Land at Lady Ann Road, Soothill, Batley, WF17 0PY
Erection of 67 dwellings with associated works including new access off Lady Ann Road, regrading works and Landscaping

I refer to the statutory response to the above planning application sent to you in the Environment Agency letter dated 21st February 2022 under reference RA/2021/143906/02-L01.

ANNEX 1: TECHNICAL EXPANATION OF THE DERIVATION OF DESIGN FLOOD LEVELS.

ANNEX 2: OVERLAY OF THE FLOOD MAP ON THE SITE LAYOUT PLAN 4026-102-U

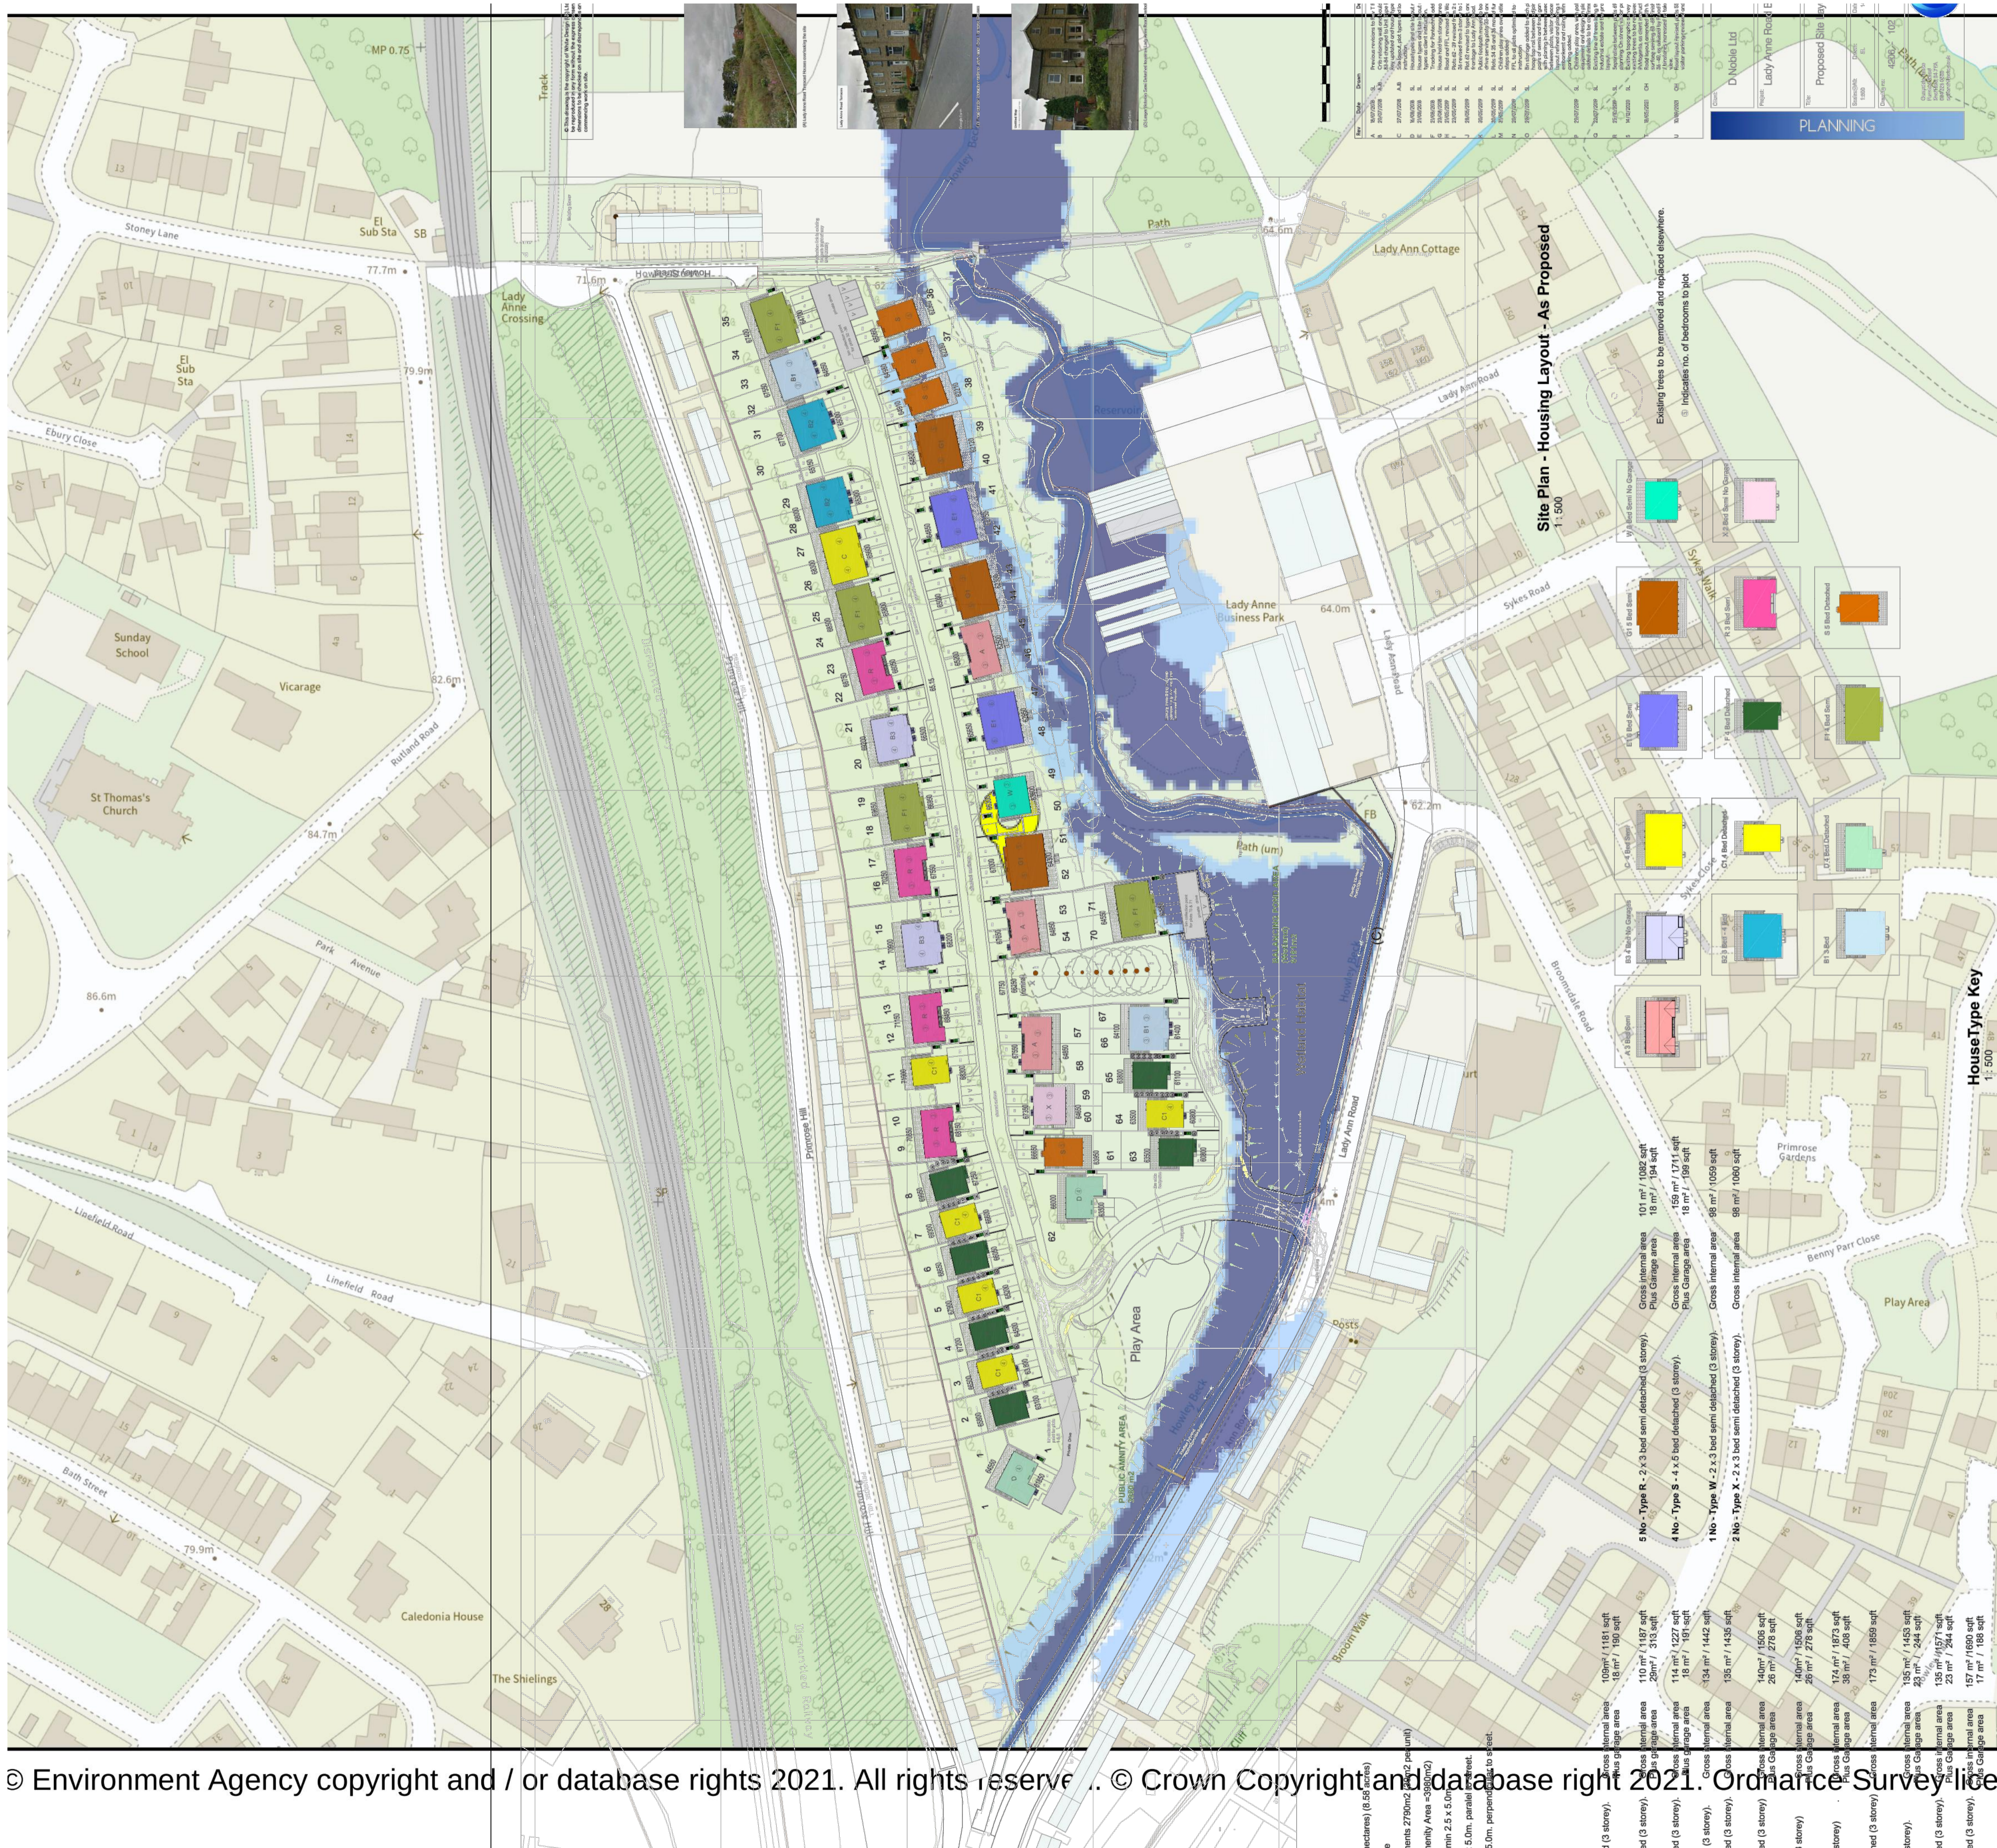
The current Flood Map for Planning has been overlaid on the current site layout plan (revision U) and Table 6.2 in the FRA report has been checked. The table is updated as follows:

Table 6.2: Identification of plots in flood zones 2 and 3 UPDATE				
	Flood Zone 2	Total in Flood Zone 2	Flood Zone 3	Total in Flood Zone 3
Plot numbers	(49)*	2	36 to 43	8
			(44 to 48)*	5
			50*	1
			70 to 71	2
Totals:		2		16

* gardens only
